CITY OF BERKLEY, MICHIGAN SPECIAL MEETING OF THE CITY PLANNING COMMISSION

Tuesday, June 7, 2022 7:00PM – City Hall Council Chambers Information: 248-658-3320

PSP-04-21: Lot 53 on Oxford Road – The Ivy: Site Plan for Phase II of the approved project at 2219
Coolidge for the removal of the existing parking lot and construction of two multiple family buildings with
a total of 24 dwelling units and a parking lot.

- 2. PSP-12-22: 28557 Woodward Seven Point Provisioning Center: Sketch Plan for the renovation of the existing building to be a retail marihuana dispensary at 28557 Woodward Avenue, Parcel #25-17-257-025, associated parking in the existing parking lot at Parcel #25-17-257-008, and proposed parking at 1299 Wiltshire Road, Parcel #25-17-257-007, and 1276 Franklin Road, Parcel #25-17-257-023.
- 3. Election of Officers
- 4. Huntington Woods Master Plan Response

LIGHTING PLAN

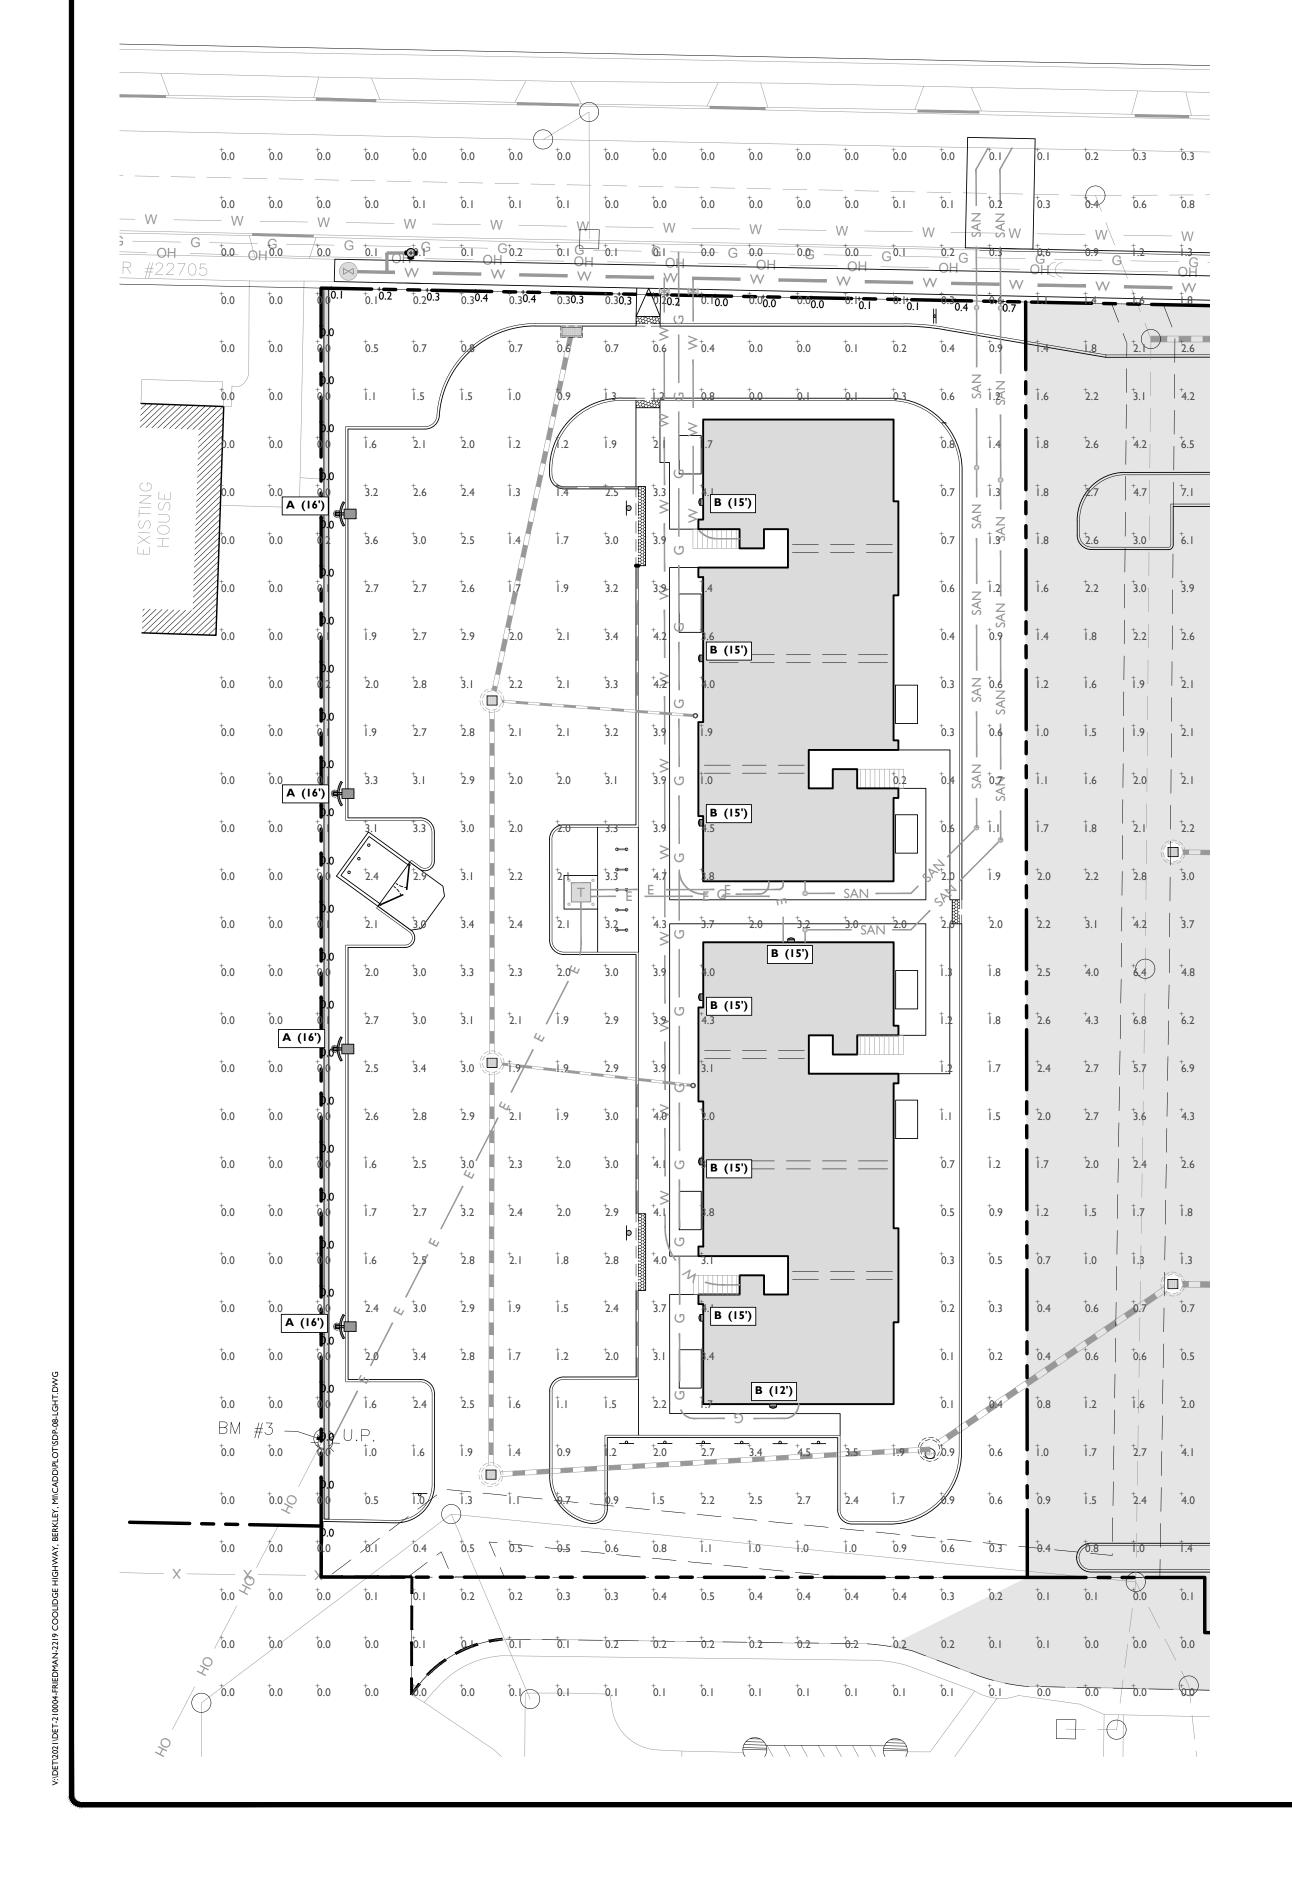
- 3. City of Berkley Material Specifications to be attached to sheet C-7.
- 4. Any existing private sanitary leads within the Oxford Road frontage of Lot 53 must be identified on the demolition plan (sheet C-3) with a proper disconnection made within 24" of the public sewer. This work will impact the roadway and traffic control plans.
- 5. A traffic control plan shall be added to the plan set to account for the proposed work on both Coolidge and on Oxford.
- 6. A construction schedule shall be provided with dates and durations of all major work items, including final restoration.
- 7. Bonding (Performance, Labor & Material and Maintenance & Guarantee) and escrow requirements will be outlined by HRC. All of the bonds and the construction escrow must be posted with the City.
- 8. Electronic as-built drawings will be required following the utility installations.

LANDSCAPING PLAN

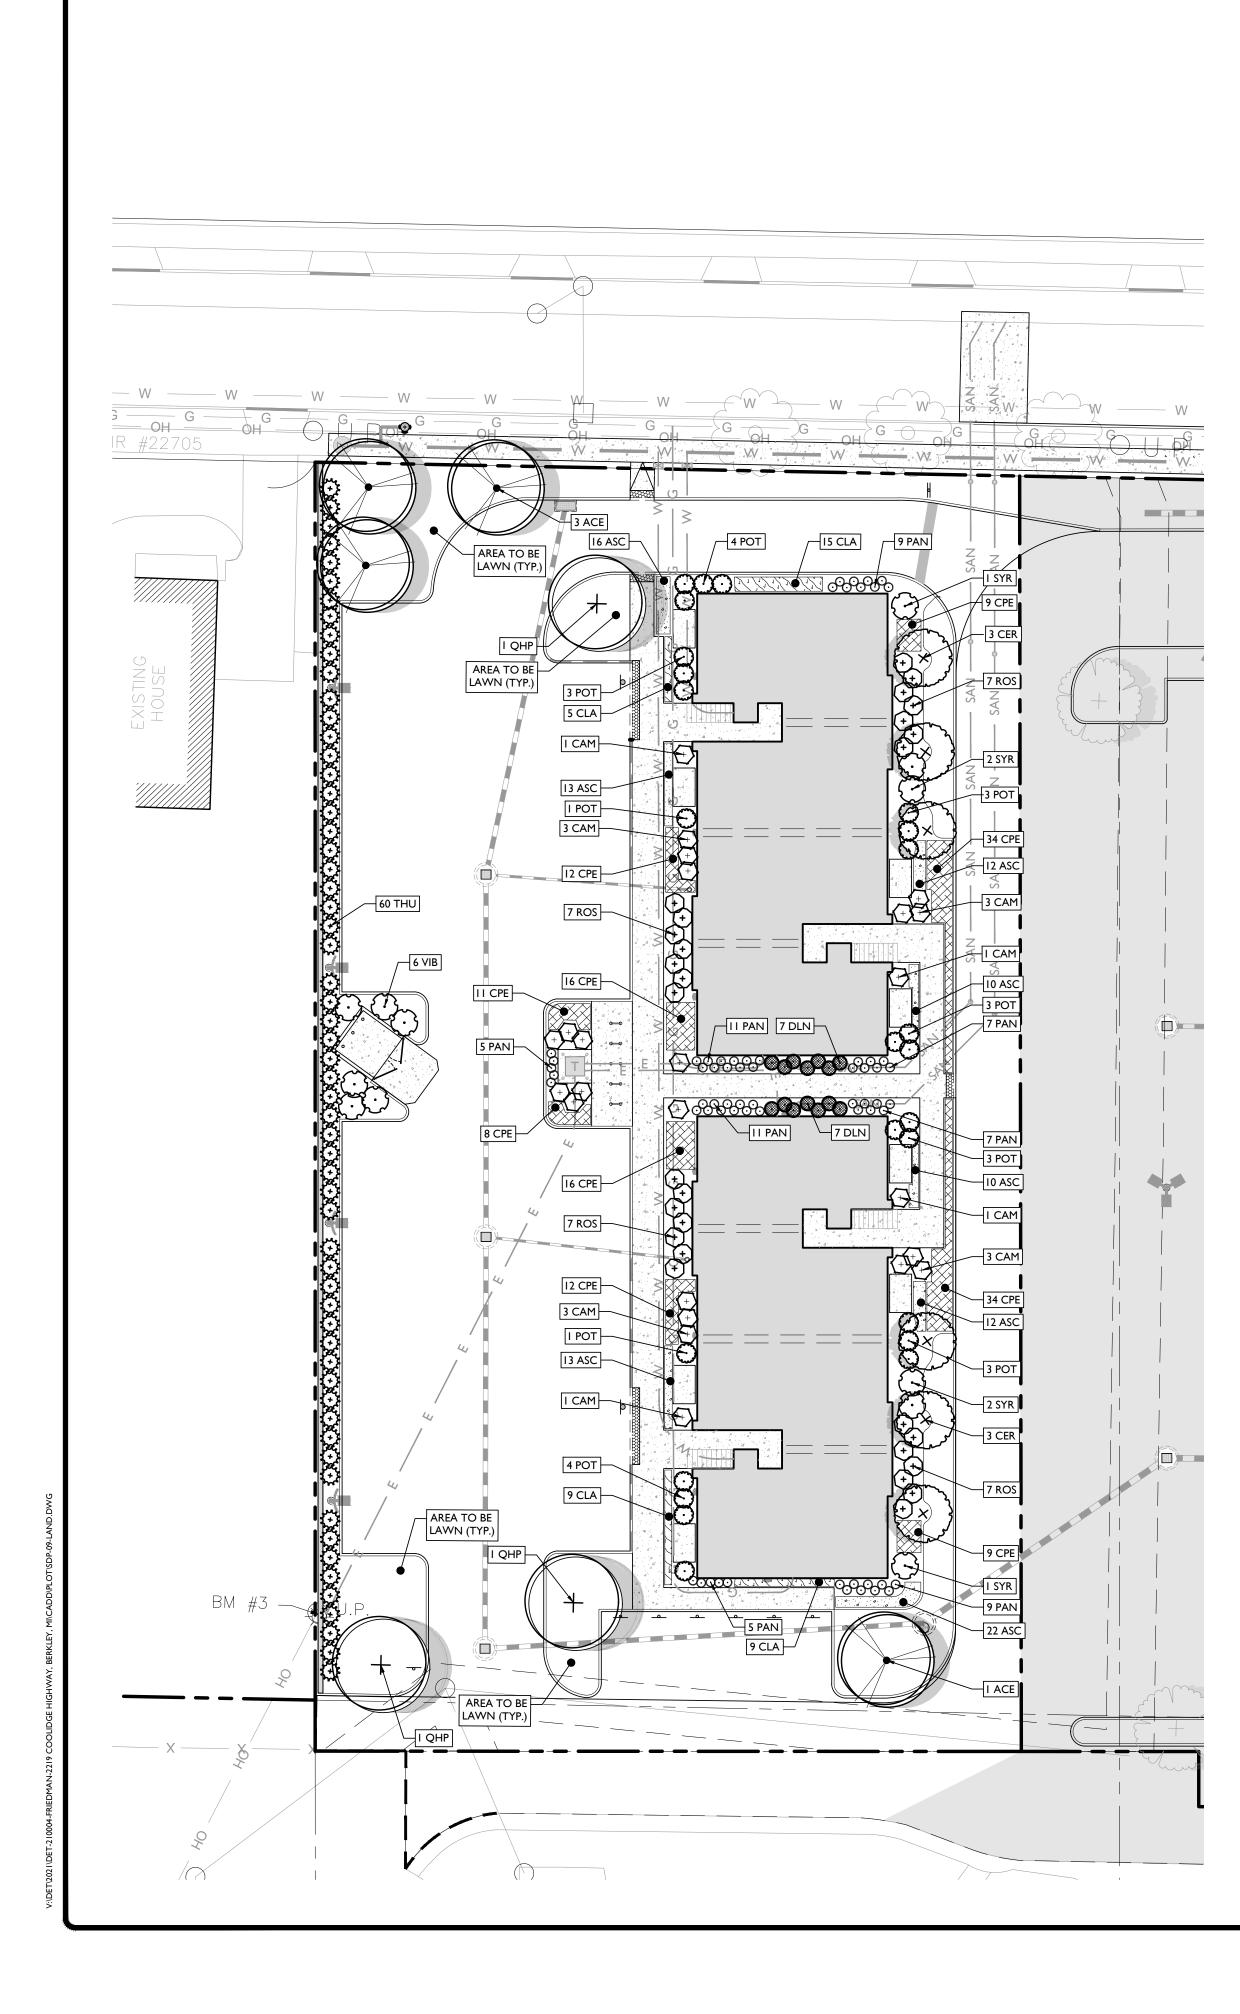
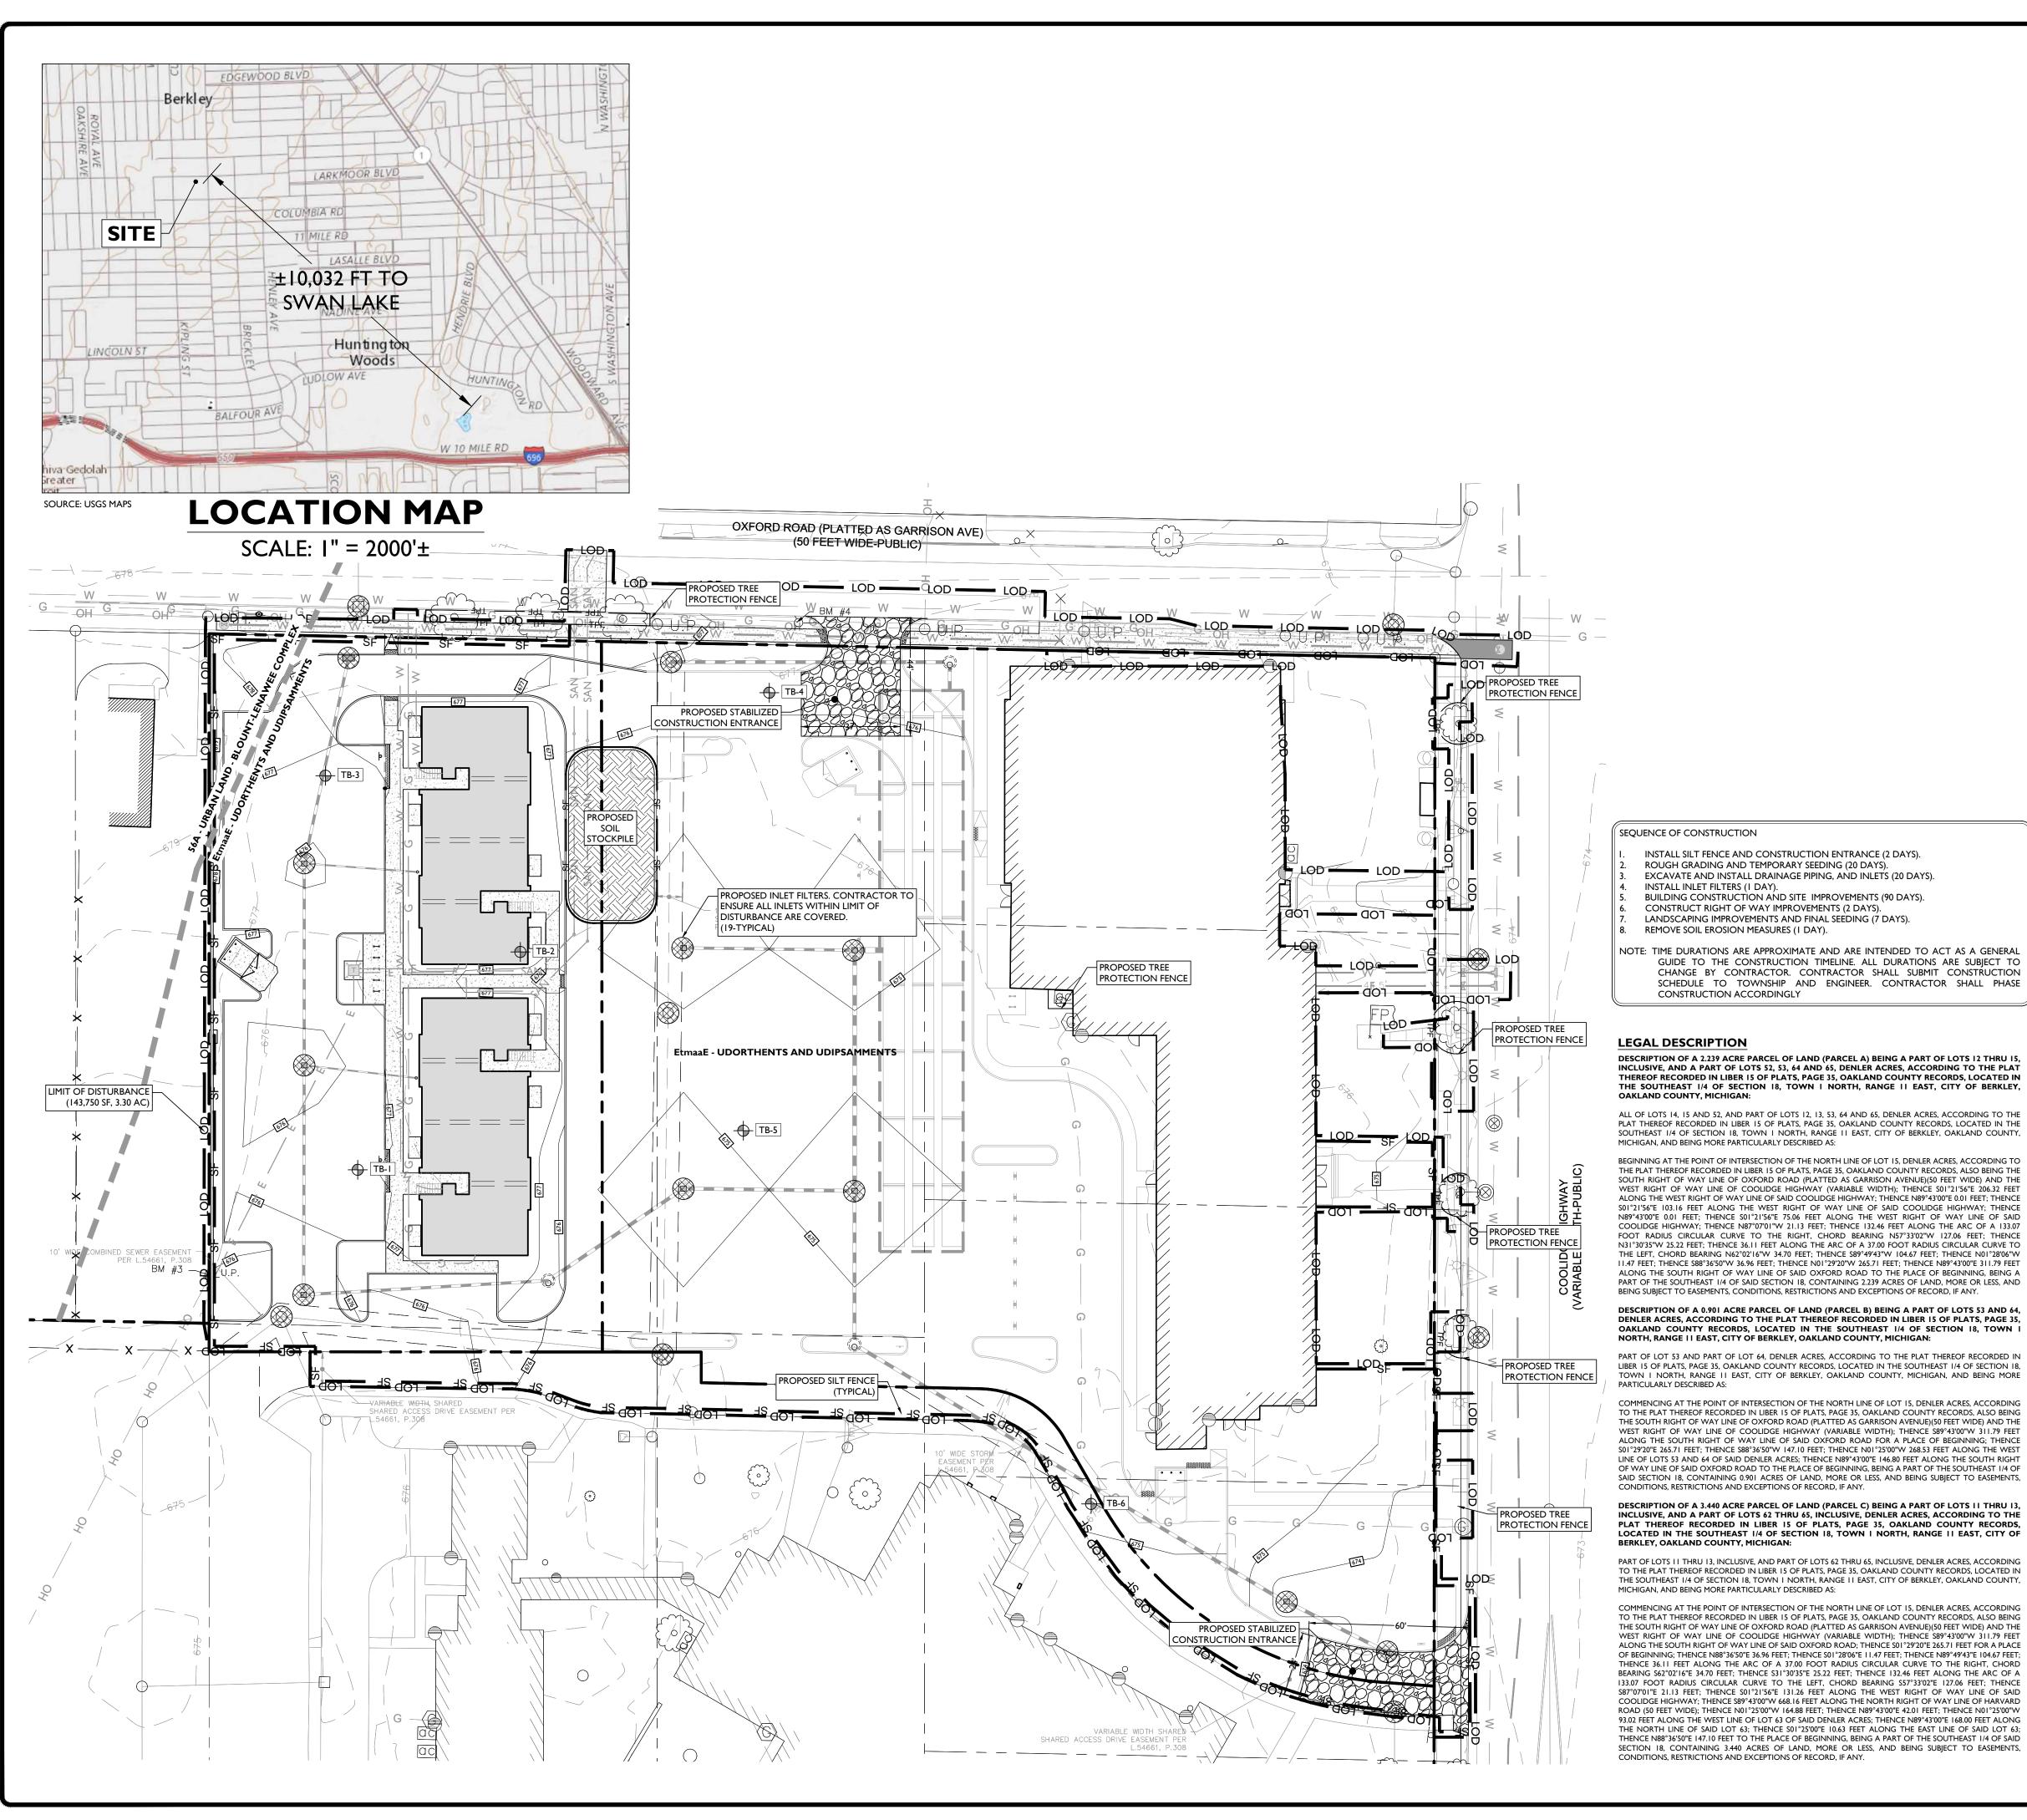
A landscaping plan has been provided on sheet C-9. The applicant proposes a mix of deciduous and evergreen trees, and shrubs. As set forth in section 130-37, when the development of any property requiring site plan approval occurs, the City Planning Commission shall review landscaping plans and may require trees to be planted on or near the site consistent with the elements of the adopted city master plan.
